SLR Consulting Australia

Project No. 610.032216.00001

**RE: 37 Archer Street, Chatswood
Response to Submissions Updated Project Description**

Figure 1 Wind Mitigation for the Development as outlined in the SSDA design – Elevated Communal Open Space (Level 6)

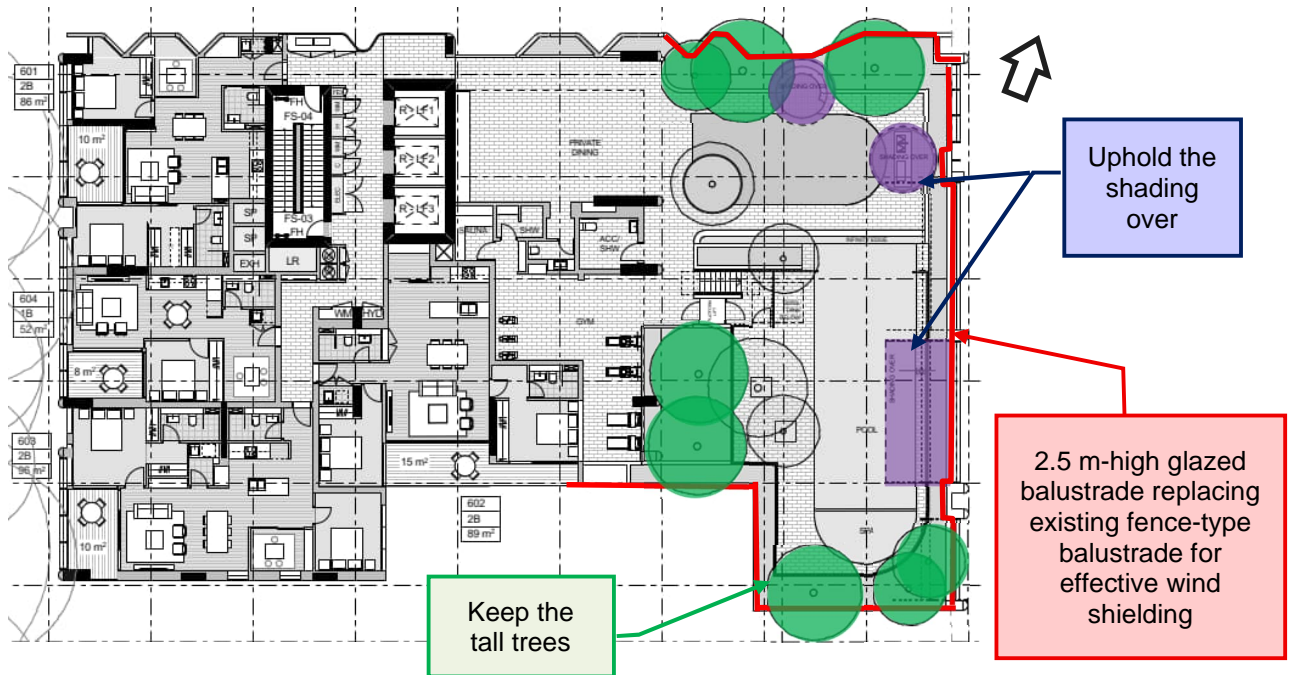
2) Detail the full heights and structural forms of the physical wind mitigation measures recommended by the wind assessment on the plans and update any references to building height accordingly.

The communal open space on level 6

The communal open space, previously located on Level 8, has now been relocated to Level 6. This modification slightly alters the local wind environment, as the lower position is less exposed to higher-level wind effects. Despite this adjustment in the updated design, the previously recommended wind mitigation measures remain applicable. Consistent with the earlier SSDA design, it is recommended that:

- Install glazed balustrades along the eastern and western edges of the Level 6 communal open space. These should be complemented by shading elements above the eastern seating areas and tall evergreen trees to improve wind protection and thermal comfort, ensuring compliance with the seating comfort criterion. (**Figure 1**).
- Wind speeds within the Level 6 communal open space, exceeded the seating comfort threshold. To address this, it is recommended to replace the proposed fence-type balustrade with a 2.5 m-high glazed balustrade to provide effective wind shielding (**Figure 1**).

Figure 2 Wind Mitigation for the Development – Rooftop

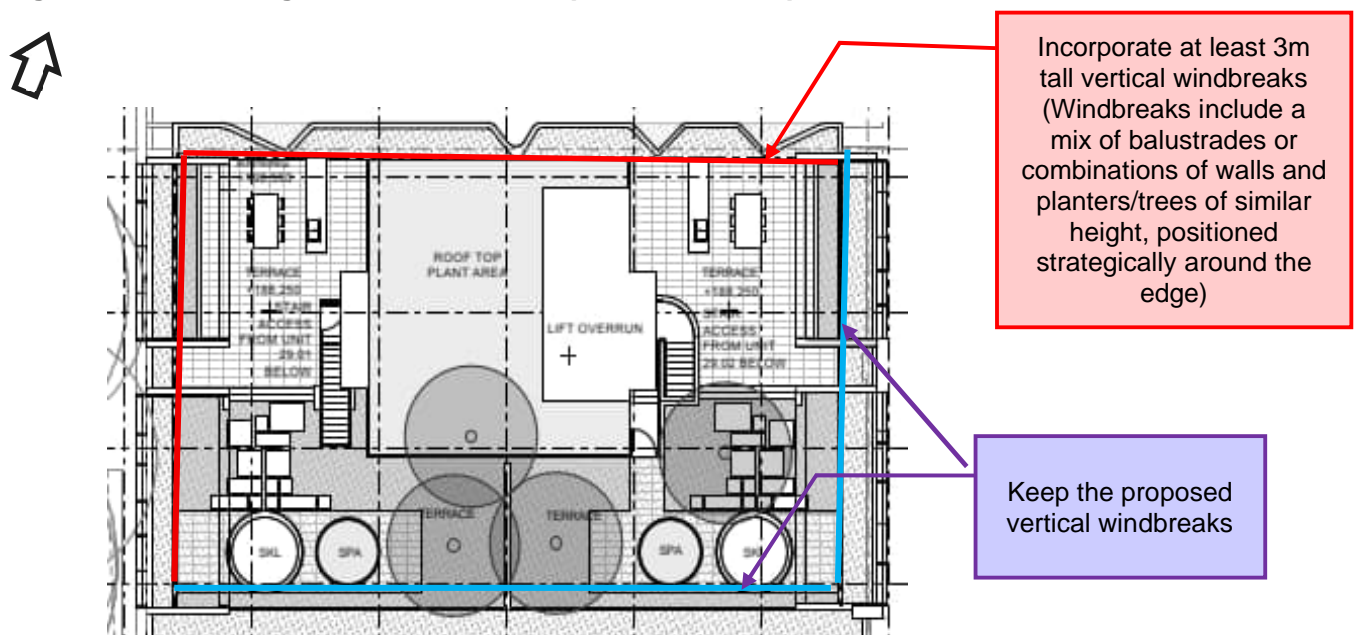
Rooftop terraces

The current rooftop design has undergone minor changes compared to the previous design; therefore, the wind mitigation recommendations have been updated accordingly, as outlined below:

- The proposed glazed balustrades along the eastern and southern outer edges of the rooftop, will help achieve the required standing comfort criteria in this area.
- It is recommended to increase the height of the vertical windbreak along the western and northern edge of this area to at least 3m to achieve the required seating comfort criteria. Windbreaks can include a mix of balustrades or combinations of walls and planters/trees of similar height, positioned strategically around the edge (**Figure 2**)
